17-115-MSP – GABE’S

Master Sign Plan (MSP) for an existing, auto-oriented commercial building.

ART Recommendation

A. Approval with 3 Conditions

1) Wall Sign – Sawmill Road

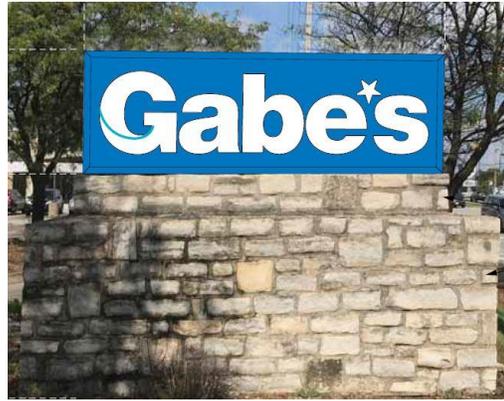
On February 1, 2018, ART reviewed the proposal and determined the request for a combination of sign types is appropriate given the site development history. ART requested the wall sign be individual, pin-mounted letters to the masonry to be consistent with the application of the Code and the previous allowance for SportMart. Additionally, ART noted the size of the sign should be reduced to meet Code. The applicant updated the wall sign in response to the comments.

An internally illuminated, individually-mounted channel letter sign is proposed above the entrance. The sign is 78.5

square feet in area and mounted at a height of 31 feet and 9.25 inches to the top of the sign. The sign face is a Gabe's corporate royal blue (PMS 2935 C) with a teal (PMS 3125 C) swoosh accent on the 'G'. The letters have a 5-inch return in white. The sign is compliant with the Code in terms of size and number of colors, but exceeds the height by nearly 17 feet.

2) Ground Sign – Sawmill Road at Martin Road

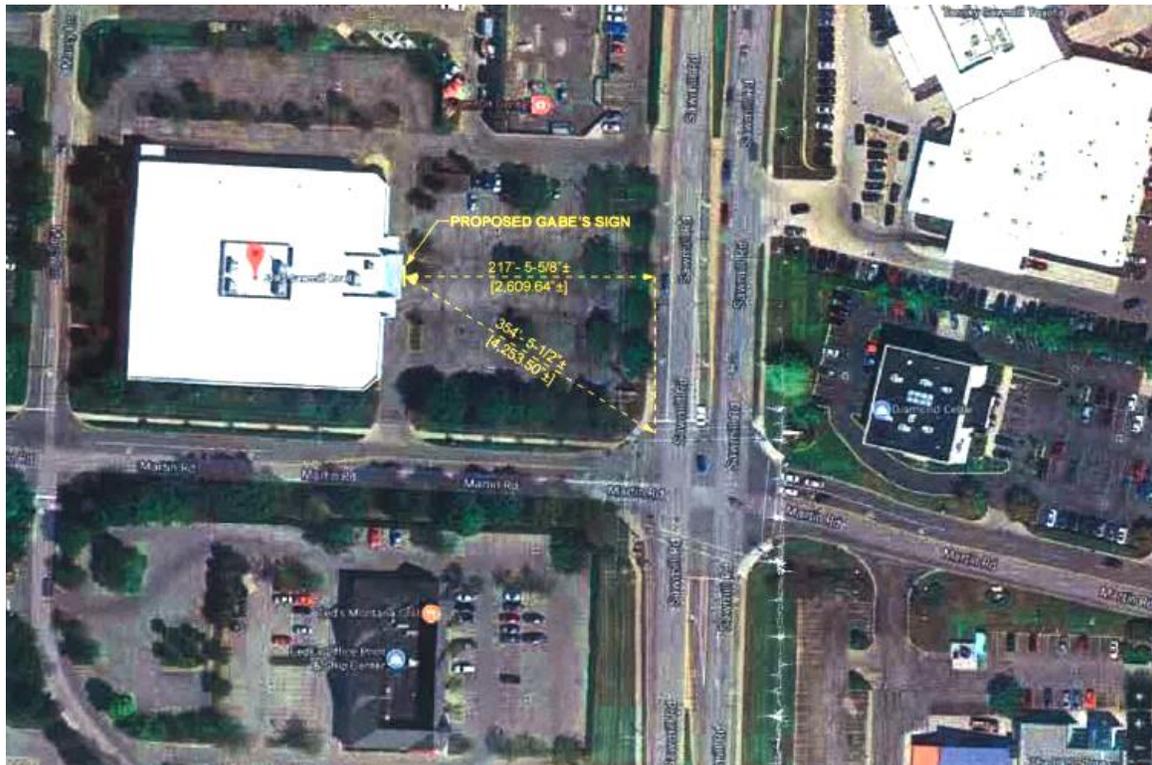
The sign has two identical faces oriented to Sawmill Road. The sign is 28.1 square feet in area and a total height, including the existing monument base, of 8.4 feet. The sign background is Gabe's corporate royal blue (PMS 2935 C) with white copy and a teal (PMS 3125 C) swoosh accent on the 'G'. The sign is compliant with Code in terms of size, height, and number of colors.

The BSD Sign Design Guidelines state all signs should be three dimensional and flat signs are discouraged. The applicant has updated the sign design since ART's review to reflect the condition requiring individually, pin-mounted, dimensional letters with a 2-inch relief and halo-illumination.

ART noted the base of the sign should be cleaned and repaired to the satisfaction of the City's Zoning Inspector and the required landscape planting around the base of the sign be provided and approved by Planning prior to issuance of the sign permit.

- 1) The ground sign design be modified, subject to Planning's approval prior to sign permitting, to be individually, pin-mounted, dimensional letters with a 2-inch relief and halo-illumination;
- 2) The masonry base be repaired and cleaned to the satisfaction of the City's Zoning Inspector; and
- 3) A plan be provided demonstrating code required landscaping at the base of the ground sign, and approved by Planning prior to issuance of a sign permit.
